DECISION OF THE PLANNING ADMINISTRATOR

CLASS 2 SITE PLAN REVIEW

APPLICATION NO.: 25-111099-PLN

REQUEST: A Class 2 Site Plan Review for a change of use and accessibility site improvements for an existing 3,558 square foot building and off-street parking area. The property is approximately 0.20 acres in size, zoned CO (Commercial Office), and located at 1097 Liberty Street SE (Marion County Assessor's Map and Tax Lot Number: 073W27CA / 6700).

1 SITE PLAN

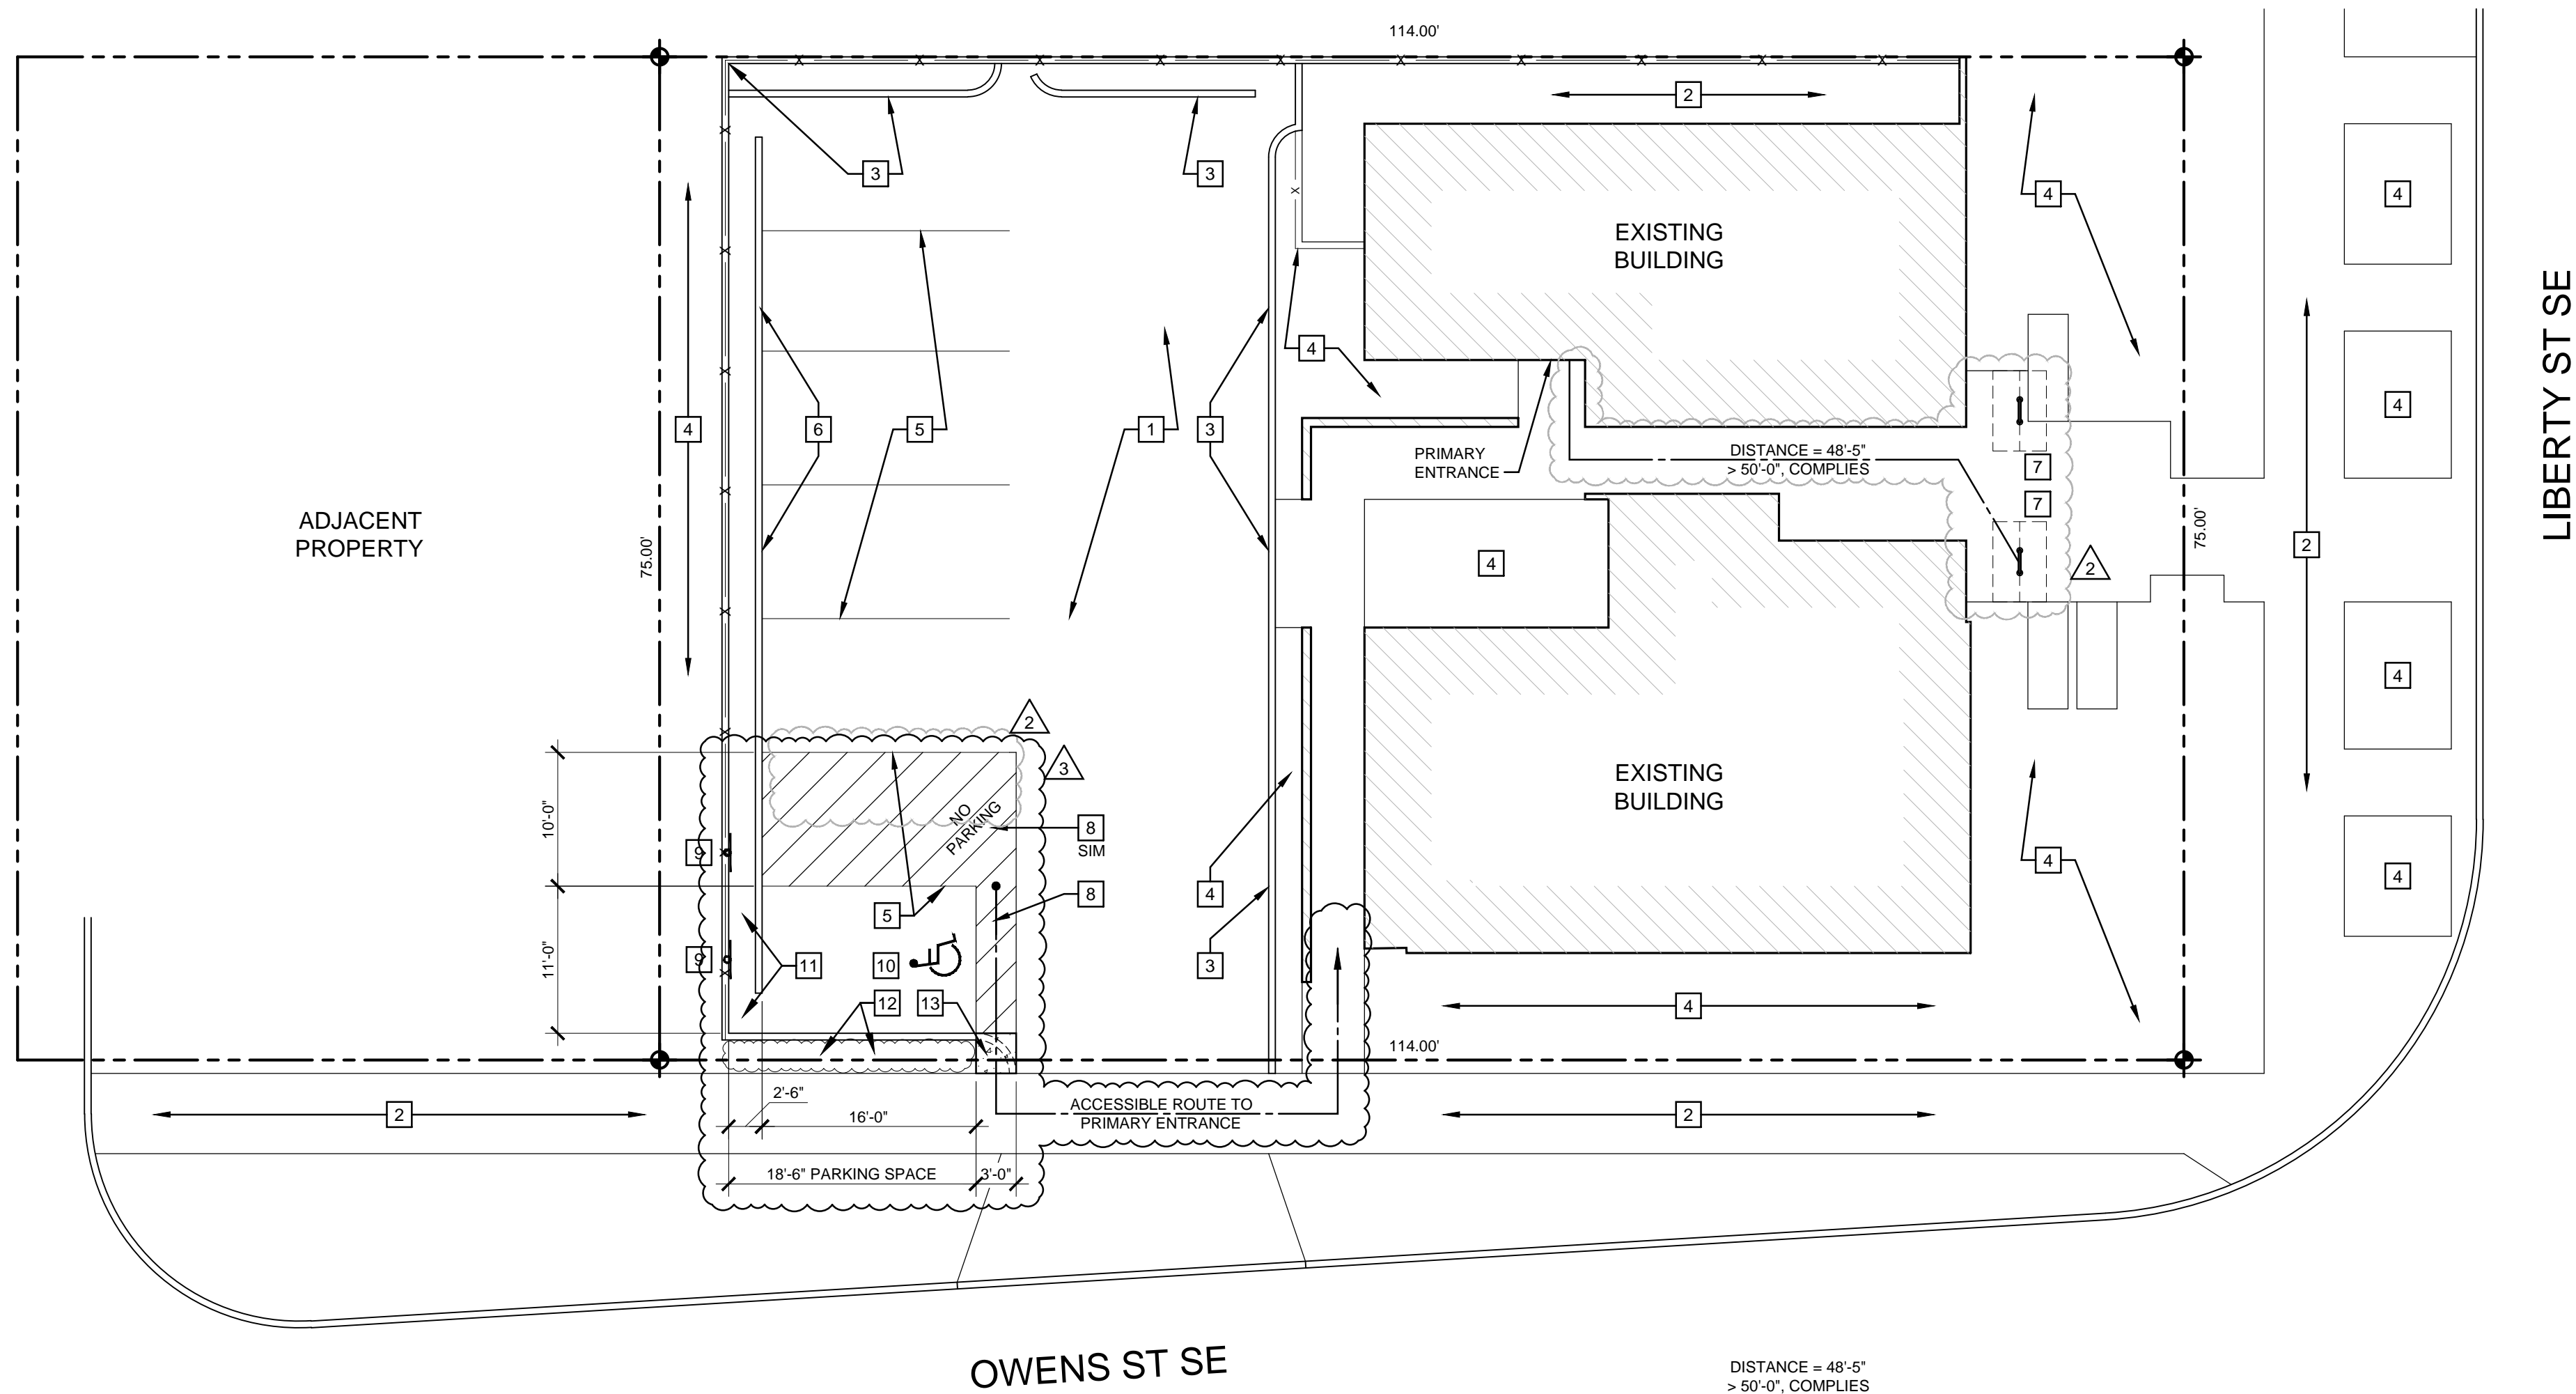
Development Services Division – Reviewed the proposal and indicated that while the existing driveway approach is considered existing nonconforming due to inadequate width, as the

proposed development will not be further narrowing the driveway approach, there are no additional concerns.

Finding: While the existing off-street parking area is nonconforming as it is setback less than 12 feet from the property line abutting Owens Street SE, the proposed development is restriping the existing space for an ADA space and removing some landscaping to create an accessible pathway to the existing sidewalk. Therefore, as no pavement is being removed, the configuration of the off-street parking area is not changing, and the setbacks for the existing building are not being altered, this standard is met.

Finding: For the 8,550 square-foot development site, a minimum 1,283 square feet of development site landscaping is required. Although some landscaping is proposed to be removed as part of the ADA parking space pathway improvements, approximately 1,880 square feet of development site landscaping will remain, meeting the standard.

Finding: The proposal includes the removal of one off-street parking space to restripe and create a new ADA parking space. Per Table 806-1 in SRC 806.015(a), an *Office* use is limited to a maximum of one off-street parking space per 250 square feet of gross floor area; therefore, the proposed development is limited to 14 off-street parking spaces ($3,558 / 250 = 14.2$). As the proposed development is reducing the number of off-street parking spaces from seven to six, and the total is still below the maximum allowed, this standard is met.

Finding: Per Table 806-9 in SRC 806.055(a), an *Office* use requires the greater of four bicycle parking spaces or one space per 10,000 square feet of gross floor area. Therefore, for the 3,558 square-foot building, a minimum of four bicycle parking spaces are required. The applicant's plans indicate that two bicycle racks (four bicycle parking spaces) will be installed on the development site, meeting the standard.

Finding: The site plan indicates the proposed bicycle parking is within 50 feet of a primary entrance; therefore, this standard is met.

Finding: As shown on the site plan, each bicycle parking area has direct access to a primary building entrance through the pedestrian pathways, free of obstruction or barriers, in conformance with the requirements of SRC 806.060(b).

Finding: Bicycle parking spaces shall be a minimum of six feet in length and one and half feet in width when the proposed bicycle racks are side-by-side. The proposed bicycle parking spaces are located on a paved walkway, with adequate dimensions to provide pedestrian passage for all four proposed spaces; the length of each proposed stall is at least six feet, while the width is at least two feet wide. The applicant is also providing a minimum five-foot-wide access aisle; therefore, the standard is met.

3 BIKE RACK PLAN DETAIL

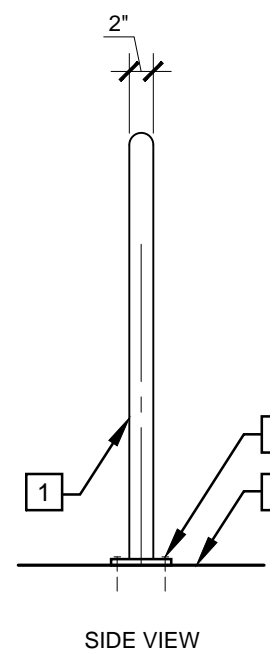
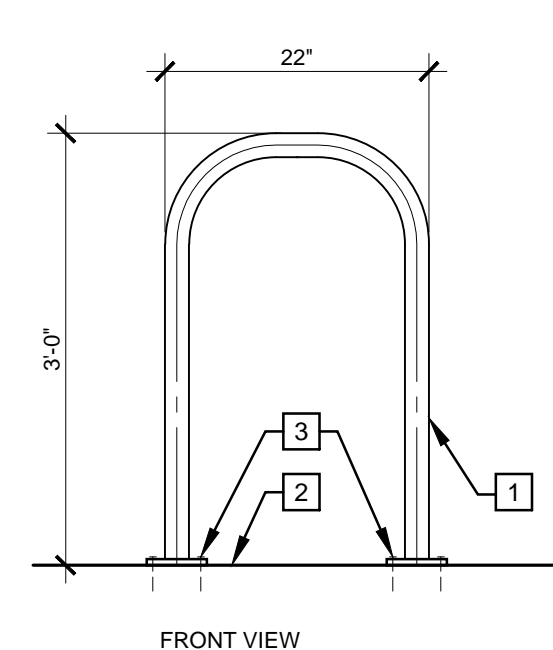
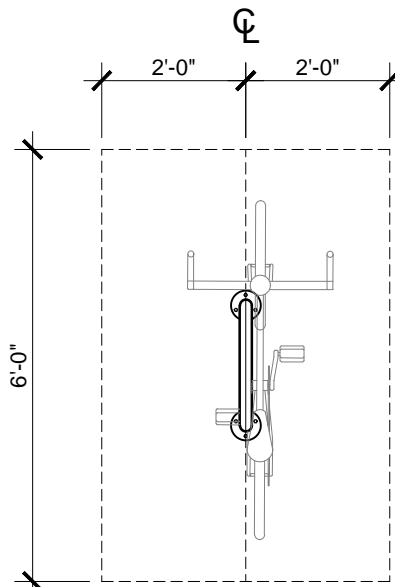
Finding: The site plan indicates inverted style bike racks will be provided. The proposed bike racks conform to the material requirements of SRC 806.060(e).
